ADDENDUM No. 2

TRANSBAY TRANSIT CENTER PROGRAM BUS STORAGE FACILITY CONTRACT NO. 17-05-BSF-000

DATE: February 24, 2017

BUS STORAGE FACILITY (Contract 17-05-BSF-000)

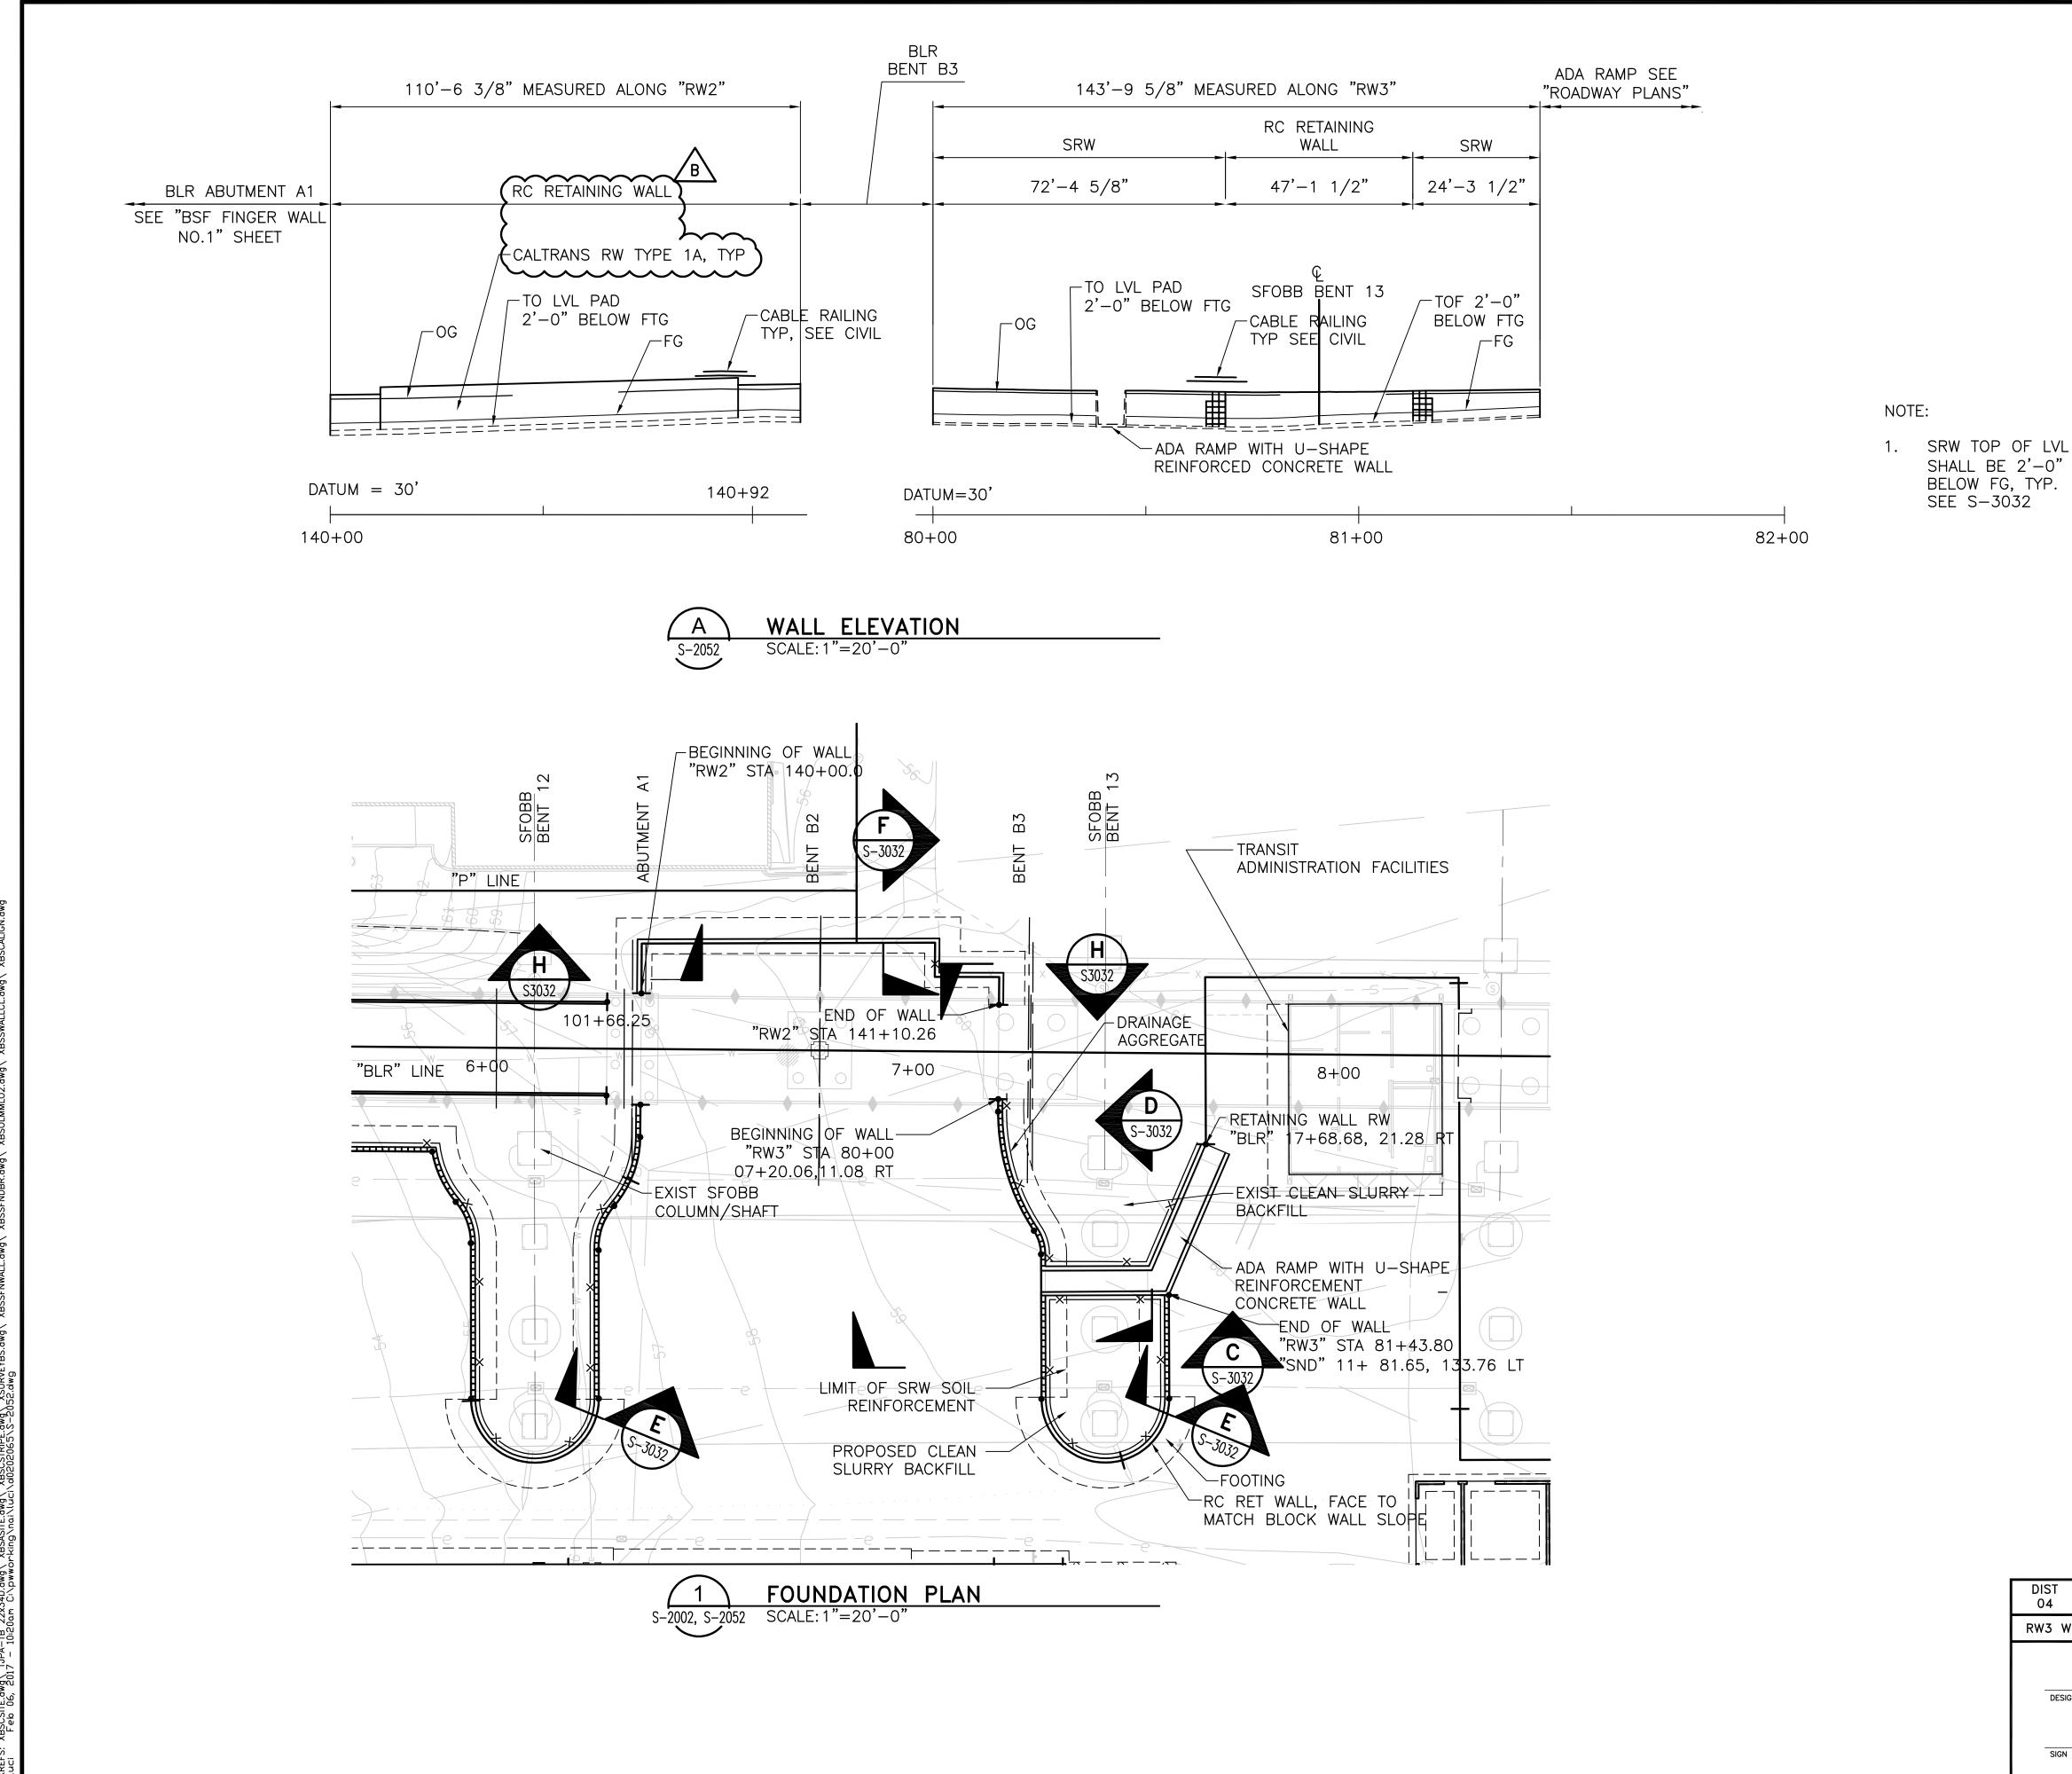
Question No.	Submission Date	5		Question	Response	
9	1.30.17		00 04 10	Bid Form page 00 04 10-3 lists damage rate per day at \$2,500. Bid Form page 00 04 10-5 lists \$3,000 per day. Please advise what the liquidated damages are for the project.	The \$2,500 indicated in Part B of the Bid Form is for bid evaluation of the A+B proposal only and is not intended to match the liquidated damages of \$3,000/day.	
10	1.31.17			Per instructions listed on this form, bidders are to submit a copy of the proof of the SBE/DBE firm listed as well as a signed 'letter of intent'. Please consider changing this requirement so that these forms can be submitted with the post-bid documents (escrow or sub certifications).	provided post-bid.	
11	1.31.17	S-2052 & S-3032		Sheet S-2052 calls out RW #2 as a segmental retaining wall. Detail F on Sheet S-3032 calls out RW #2 as a Caltrans Type 1A. Which is it?	Retaining Wall #2 is to be a Caltrans RW Type 1A, per the details on Sheet S-3032. A revised Sheet S-2052 with a corrected callout is attached and will be issued in an upcoming addendum.

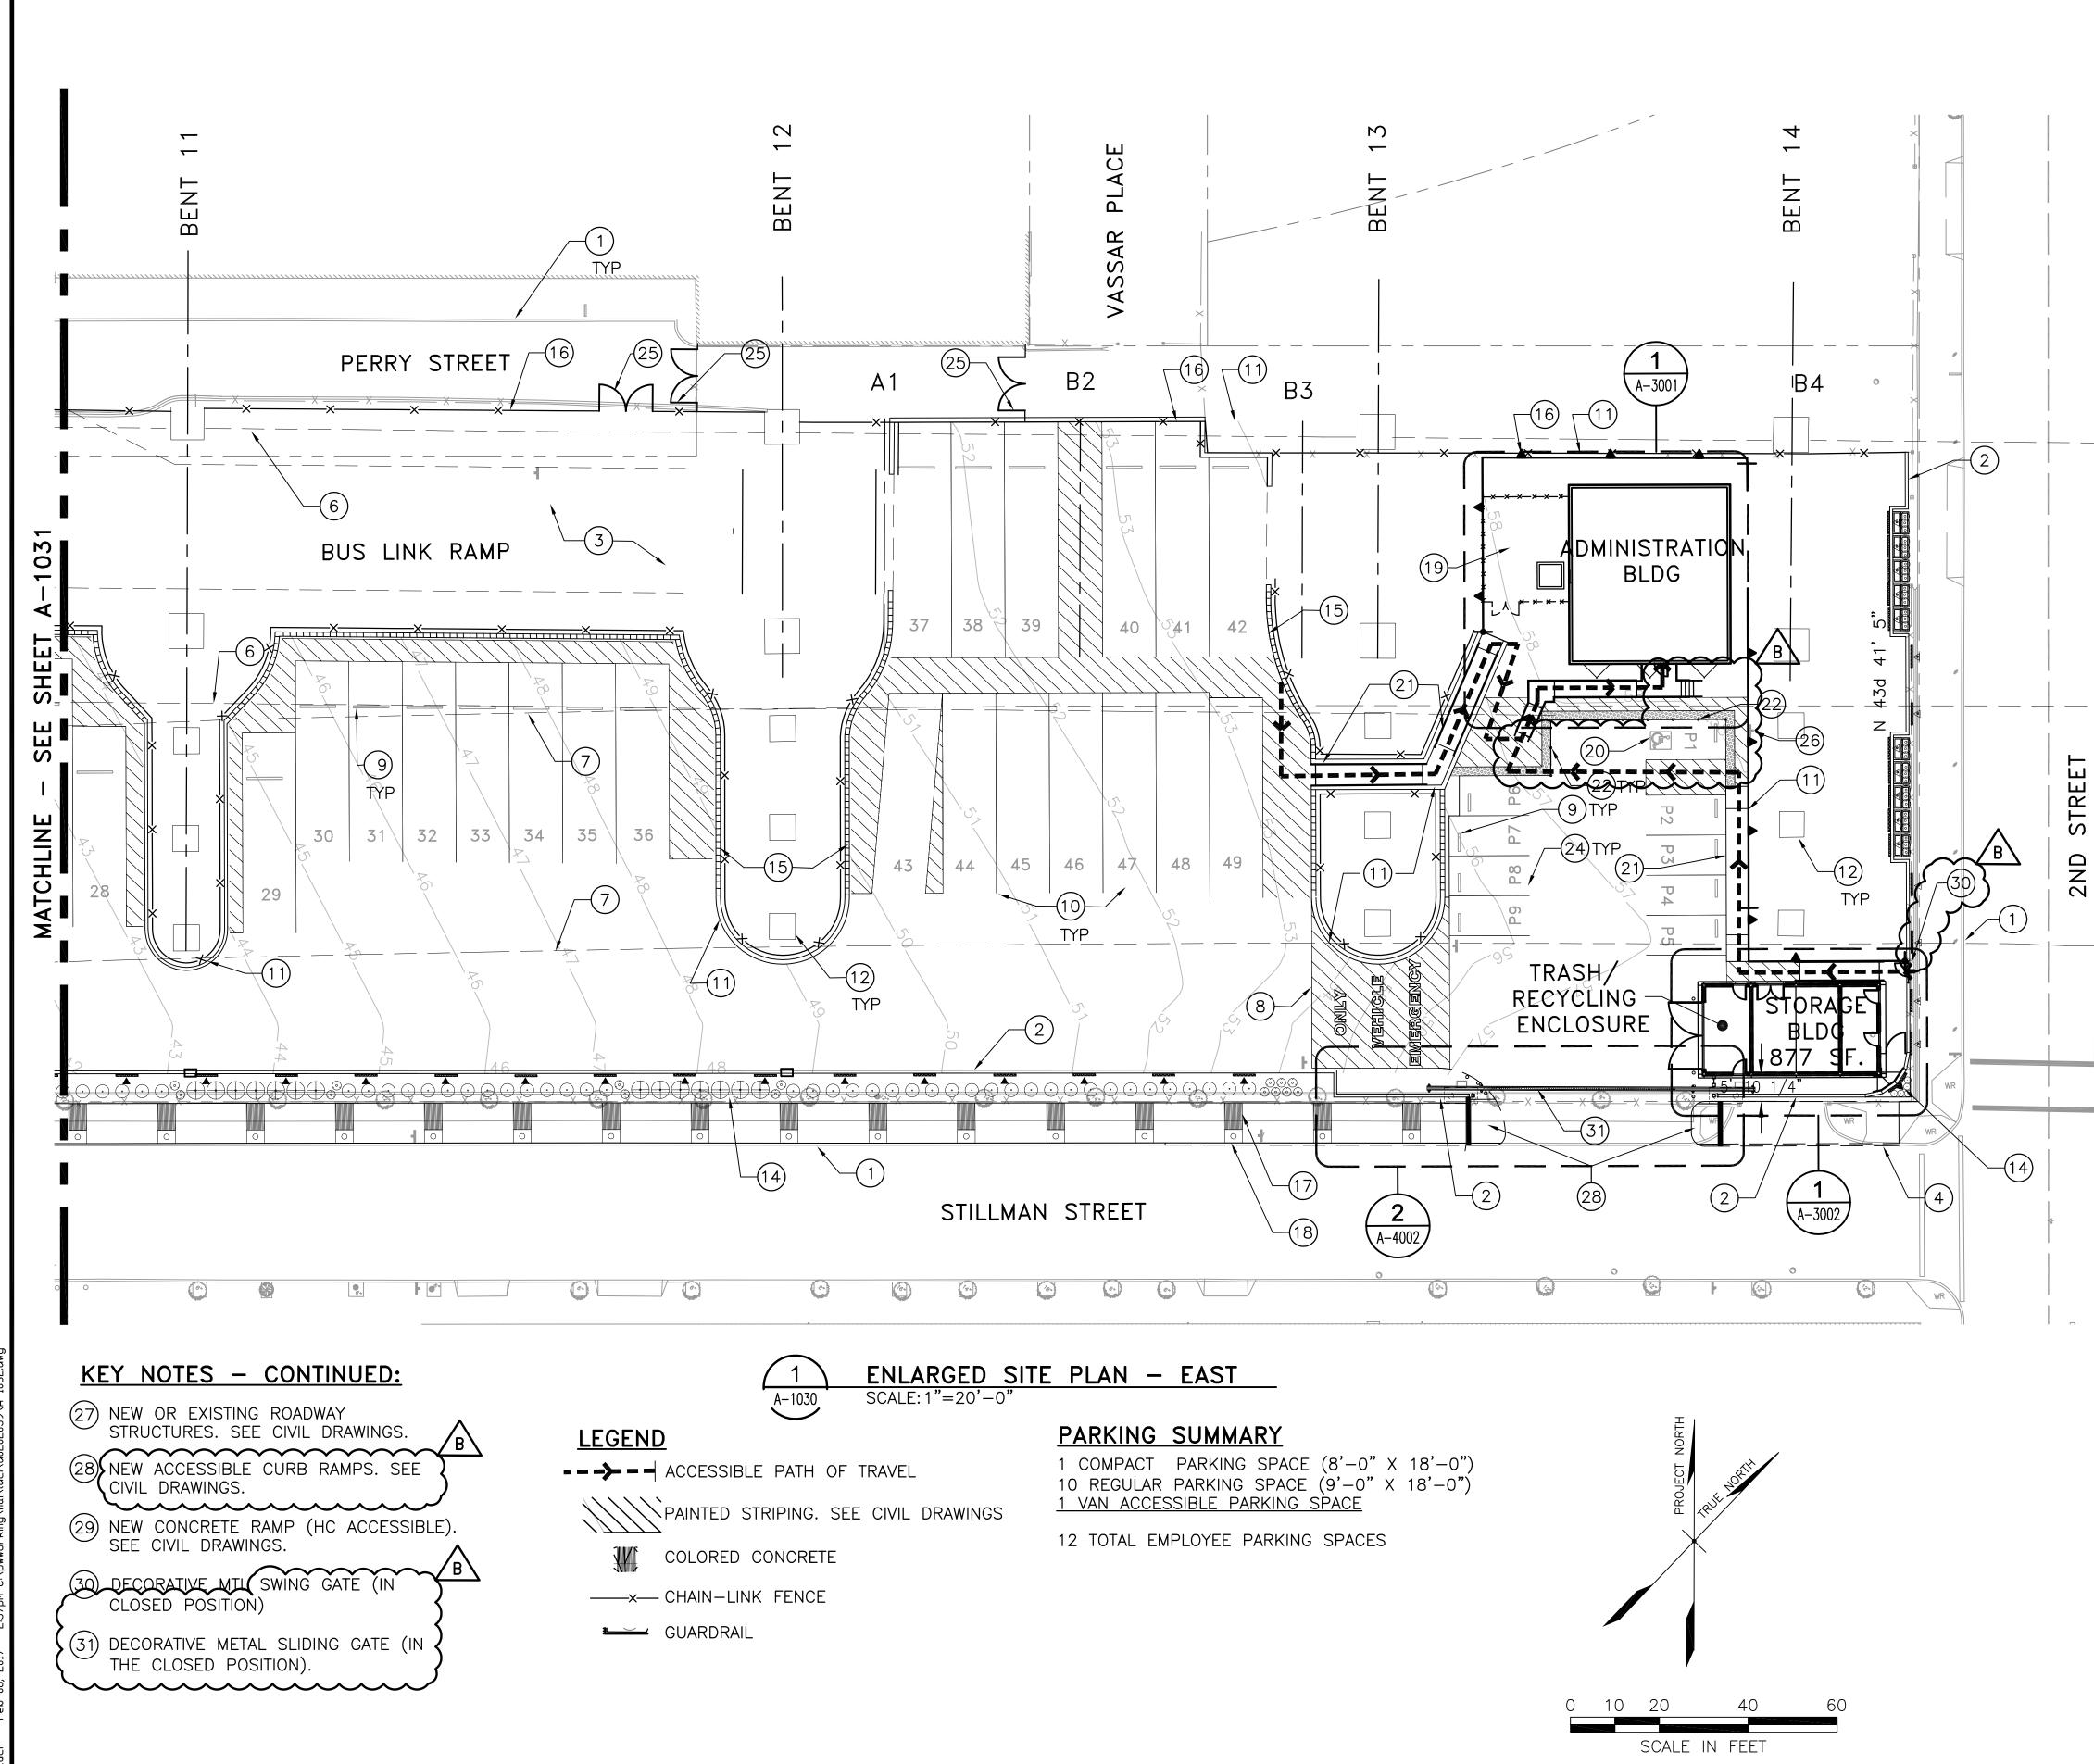
12	2.1.17	C-2001		Can you tell us what color the colored concrete sidewalk is?	Sidewalk color is to comply with San Francisco Public Works standards.	
13	2.1.17	C-2002, A-1032		There are three maintenance gates shown on the plans at Perry Street. The architectural plans indicate them with note 25, "Not Used". Are we installing gates as shown and if so, what is the style of each of the gates?	See the attached revised Sheet A-1032 for updated gate information.	
14	2.1.17			Regarding the TL4 Crash System, who can I contact for clarification of this scope to submit an accurate bid?	Per Specification Section 00 02 00 paragraph 1.4, Interpretations and Addenda, all questions on the bid documents must be submitted in writing using the QBD form included in Section 00 02 00-AT1.	
15	2.1.17			In regards to Sheets C-1001 and C-1002 titled Existing Condition and Demo plan, it is noted by the legend and shown on the plan views of the subject drawings that the contractor is to remove buried foundations as needed. Should the contractor assume all of the referenced buried foundations are below the elevation of flatwork demo and below the elevation required to install the permanent 12" unreinforced concrete paving and required 8" of base as shown on sheets C-2001 and C-2002, as well as any foundations for permanent structures or walls. Or will the elevations be provided to what depth these foundations have been demolished to?
